Subject: Response to U.S. Nuclear Regulatory Commission Request for Additional Information Regarding Inservice Inspection Relief Requests RI-21, Revision 2, and RI-36
Cooper Nuclear Station, Docket No. 50-298, DPR-46

**Response to NRC Request for Additional Information Regarding
Inservice Inspection Relief Requests RI-21, Revision 2, and RI-36**

**Nebraska Public Power District
Cooper Nuclear Station**

Sketch Of Limitation(s):

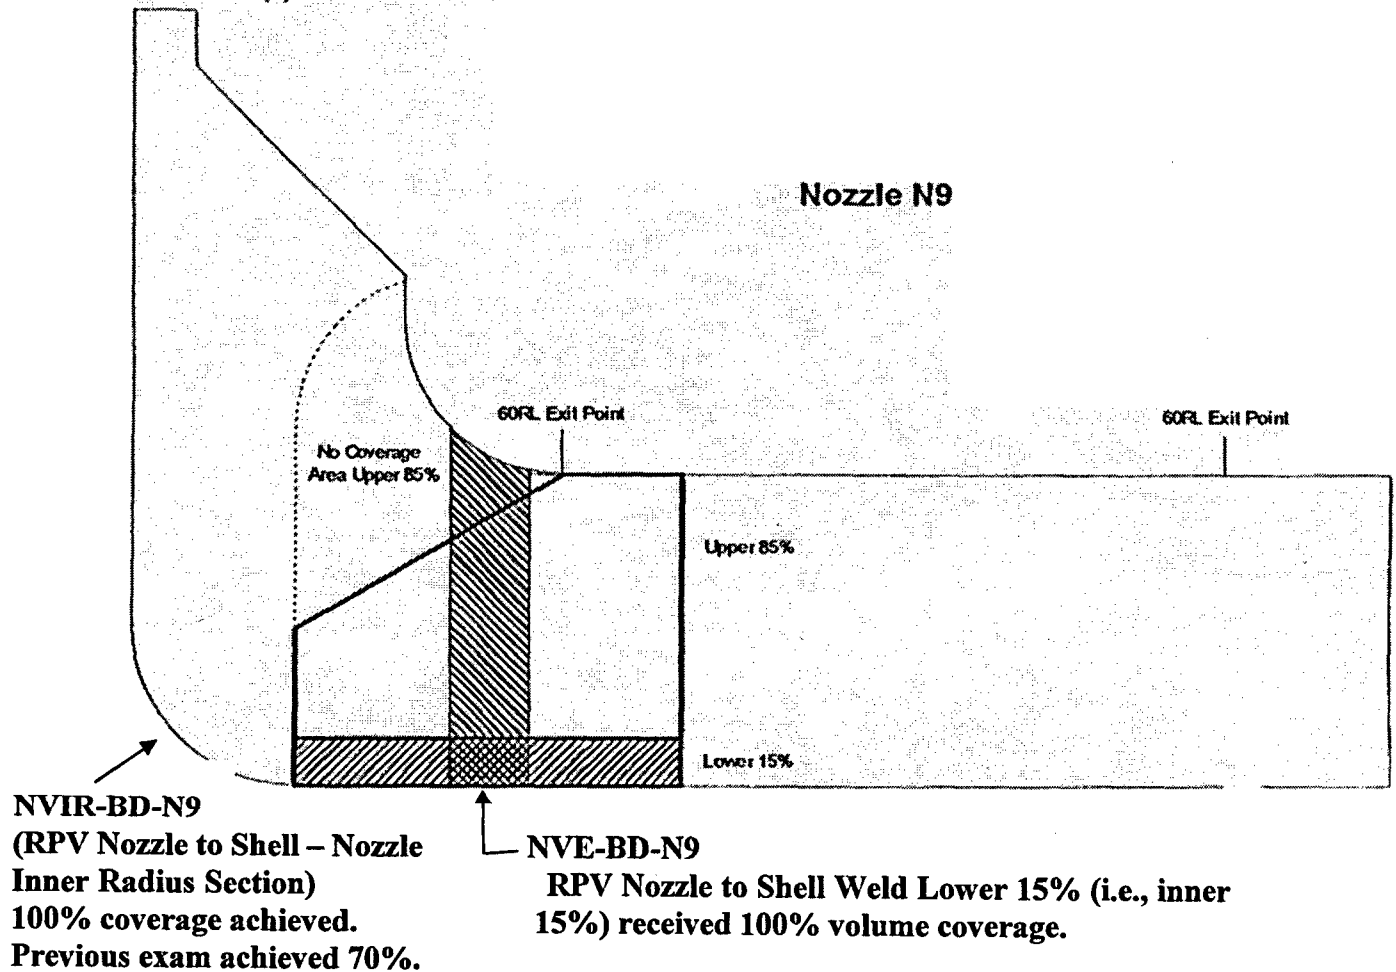
The licensee stated that the total volumetric examination coverage of nozzle NVE-BD-N9 was 40 percent. The figure in the attachment to the September 28, 2005, letter does not provide sufficient information regarding how the 40 percent coverage was achieved. Please demonstrate the 40 percent coverage by calculations and diagrams.

The submittal stated that the inner radius examination of nozzle NVE-BD-N9 in the third interval achieved 100 percent of the required examination volume. It also stated that the inner 15 percent of the nozzle received 100 percent coverage. Discuss why the volumetric examination can achieve 100 percent coverage in the inner radius region, but only 40 percent coverage was achieved.

The ultrasonic examination volume includes the outer 85 percent thickness and the inner 15 percent thickness as measured from the inside diameter surface. The 60 degree RL scans were used to examine the entire weld volume with the exception of the lower 15 percent in the circumferential direction. The EPRI Model parameters were used to inspect the lower 15 percent of the examination volume using the required shear wave scans.

The 60 degree RL/Zone -1 and the 60 degree RL/Zone -2 scans, along with the combined model scans were used to calculate the total examination coverage and limited/no scan area not covered by these techniques. The examination limitations are shown in square inches in order to simplify calculations.

The figure below shows the examination volume limitations to the applicable examination zones as required per ASME Section XI, Figure IWB-2500-7(a).

The nozzle is divided into two distinct examination zones: the nozzle-to-shell weld zone (ASME Code Item B3.90) and the inner radius zone (ASME Code Item B3.100). Each zone for the N9 nozzle has two distinctive component identifiers in the Cooper Nuclear Station (CNS) Inservice Inspection (ISI) Program. The nozzle-to-shell weld is identified as NVE-BD-N9, and the inner radius zone is identified as NVIR-BD-N9. The nozzle-to-shell weld zone and also the inner radius zone each have their own respective code volumes that are required to receive a volumetric examination. Figure IWB-2500-7(a), "Nozzle in Shell or Head," illustrates the most applicable examination zones for CNS. Zone M-N-O-P is the inner radius zone, and Zone A-B-G-H-I is the nozzle-to-shell weld zone.

The 40 percent coverage stated in the relief request only applies to the nozzle-to-shell weld zone NVE-BD-N9. Within the required examination volume associated with NVE-BD-N9, that zone or volume is divided into the lower 15 percent region and upper 85 percent region of the nozzle-to-shell weld examination volume. The relief request stated that 100 percent coverage was achieved for the lower 15 percent region, which is the region of most concern for flaw initiation. The upper (outer) 85 percent region is less of a concern.

The figure on Page 3 of this attachment shows the exam volume associated with NVE-BD-N9 and NVIR-BD-N9. The inner radius zone (NVIR-BD-N9) is a different exam volume than the inner 15 percent region shown as the cross-hatched area in the figure. The area to the left of the cross-hatched area is the inner radius zone that is examined under a different technique and reported on a different data sheet. With our most recent examination, we achieved 100 percent of the inner radius zone compared to 70 percent in Interval 2 (1995). Since we achieved 100 percent code-required volume for the inner radius zone, we revised the table in the relief request to remove the inner radius zone coverage of 70 percent that was previously approved by the NRC in Revision 1 of the relief request.

Sketch Of Limitation(s):

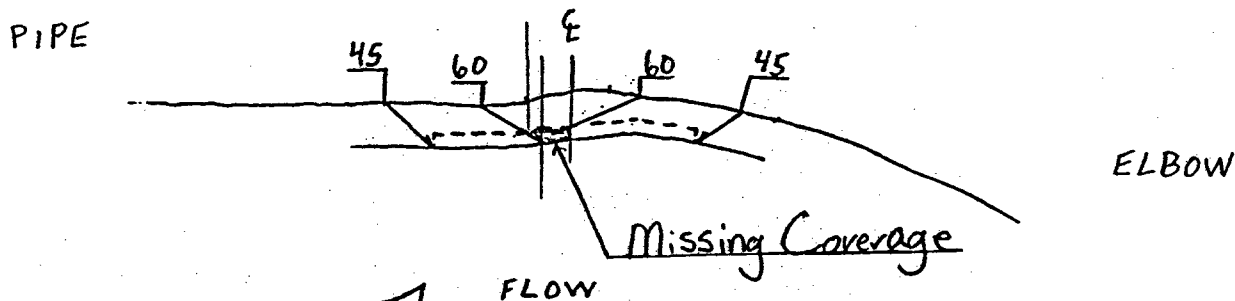
Provide a drawing of the subject welds RVD-BJ-17 and RVD-BJ-18, including the volume that were volumetrically examined, angle and trace of transmitting and receiving signals, and examination interferences.

The drawings of the welds are provided on the enclosed Ultrasonic Examination Scan Limitation Sheets (page 5 of 5 for each data set) for Welds RVD-BJ-17 and RVD-BJ-18.

The limitation was due to the "as welded" crown. (See the enclosed Ultrasonic Examination Scan Limitation Sheets, page 5 of 5 for each data set.) Conditioning the crown may have achieved more examination volume coverage; however, the inadvertent removal of weld metal below code minimum on a thin material may have occurred on one or both of the segments and, therefore, was not performed. There were no other interferences identified.

Customer: Cooper Nuclear Station, NPPD		Component: 2" ELBOW TO PIPE		Summary No.: B9.21.0033.R1	
Weld No.: RVD-BJ-18				Percent Of Exam Completed (Calculations Or Comments Below) 84.85% code volume achieved. Total coverage missing .015" ² .099" ² total area of lower ½ = .099" ² - .015" ² = .084" ² .084" ² + .099" ² = .8485 .8485 × 100 = 84.85% total coverage obtained	
Reference Point N/A					
1) Interfering Condition AS WELDED WELD CROWN					
Distance From Centerline	N/A	To	N/A		
Distance From Ref. Point	N/A	To	N/A		
2) Interfering Condition N/A					
Distance From Centerline	N/A	To	N/A		
Distance From Ref. Point	N/A	To	N/A		
3) Interfering Condition N/A					
Distance From Centerline	N/A	To	N/A		
Distance From Ref. Point	N/A	To	N/A		
(For All Measurements Indicate: US, DS, CW, CCW)
